**D-Link Systems, Inc.™**  
**xStack Storage DSN-3200 & DSN-3400**  
**ECN – Drive Activity Light Fix (rev. 1)**

This document is an ECN (Engineering Change Notice) concerning the identification of affected DSN-3200/3400 units shipped before January 2008 and the installation of four resistor packs to fix the issue.

**Figure 4: Identifying the four 10-position headers**

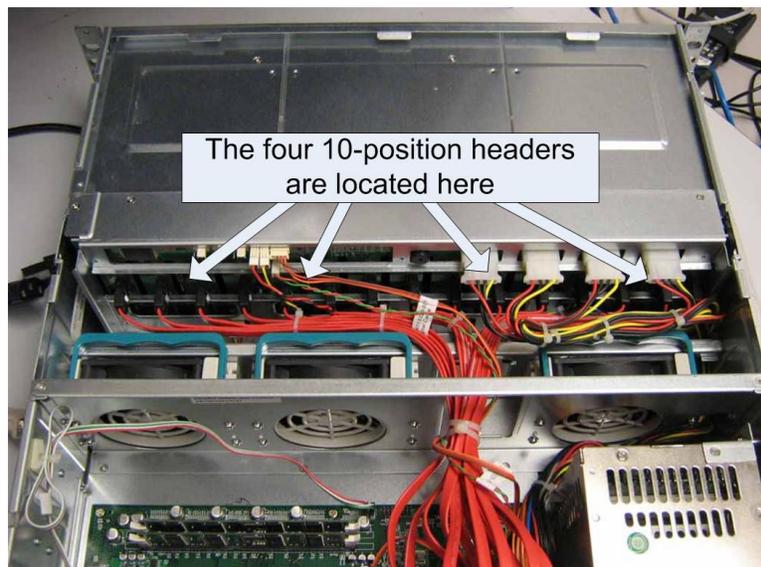
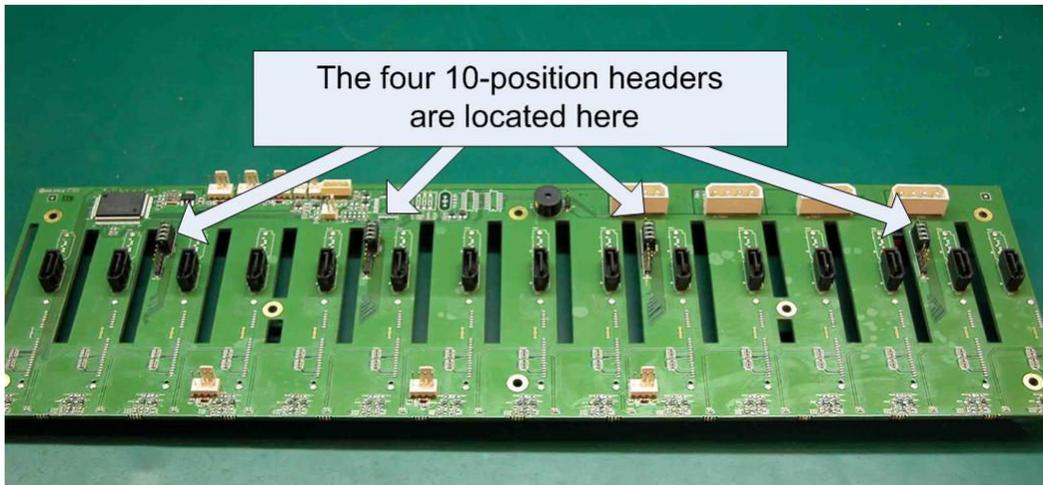
Step 6) Located on the backplane are four 10-position headers labeled NA1315, NA0912, NA0508 and NA0104. The labels themselves are extremely small and difficult to read. Please see figure 4 to identify these headers. Note that the two right-most headers are made difficult to see because of the placement of four (4) four-position Molex power connectors. (In order to better orient you to the position of these jumpers, please see the bare backplane and identified headers shown in figure 5)

Step 4) Identify the four 10-position headers as shown in figures 4 & 5. The two right-most headers are blocked by the power connectors. Remove the two (2) Molex power connectors labeled CN4 and CN7 to gain easier access to the two (2) 10-position jumpers found below them. Please see figure 8 for details.

**Figure 6: A jumper block installed on a 10-position jumper**

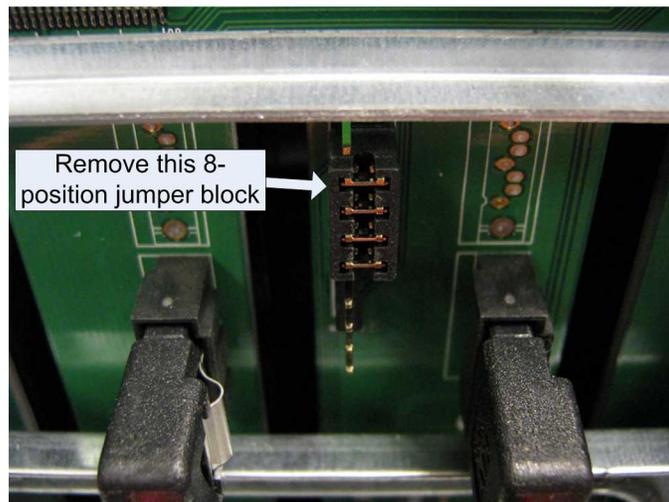
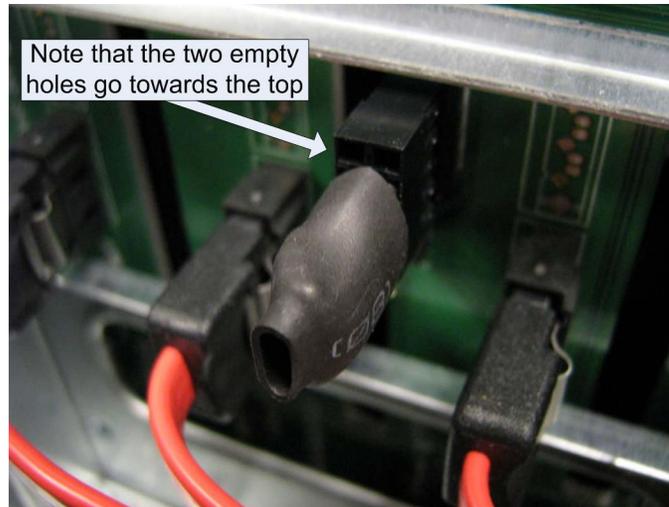
Step 7) If you see a jumper block installed on each of these four headers like that shown in Figure 6, then you will need to proceed to Section 2 for instructions on installing the new resistor packs. If you see a modified jumper like that found in figure 7, then your system has been modified with the necessary resistor packs. You may close your unit's cover and return to normal operation.

If you have followed the steps outlined in Section 1.3 and determined that you need to install the resistor pack modification, then please contact D-Link or your reseller to obtain the four (4) necessary resistor packs. These resistor packs will take the place of each of the four jumpers found on the four 10-position headers labeled NA1315, NA0912, NA0508 and NA0104.

Step 8) Carefully orient the resistor pack over the 10-position header, making sure the keyed hole matches the missing pin on the header. Press the resistor pack inwards until it is firmly seated. Figures 12 & 13 will give you a guide to what it will look like.

**Figure 9: The empty 10-position header**

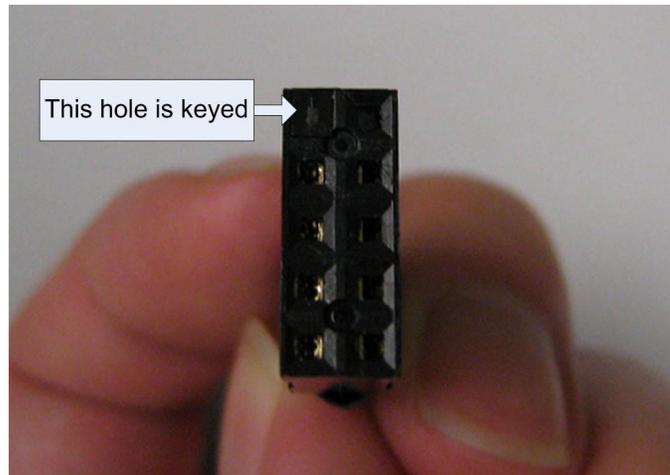
Step 6) For each 10-position header, you must remove the 4-position jumper block as seen in figure 6. You will then see an empty 10-position header like that shown in figure 9. The top-right pin is removed and will provide a guide for installation of the new resistor pack.

**Figure 10: The resistor pack: side view**

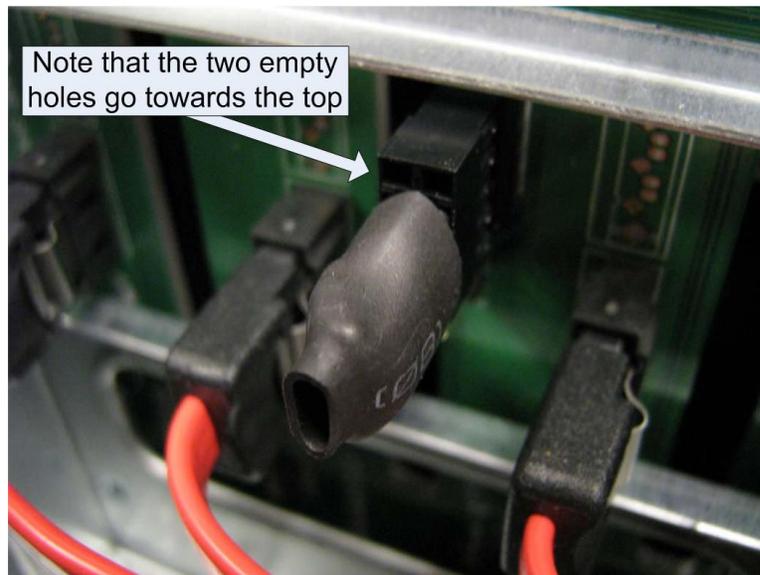
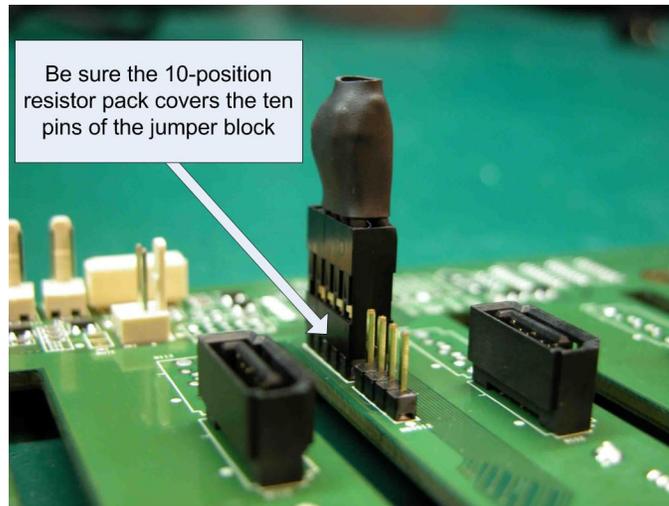
Step 7) Familiarize yourself with the resistor pack. Note that two of the positions are empty as seen in figure 10. Also be aware that one of the holes on the connector has been blocked as shown in figure 11. This blocked hole will need to match with the missing pin shown in figure 9.
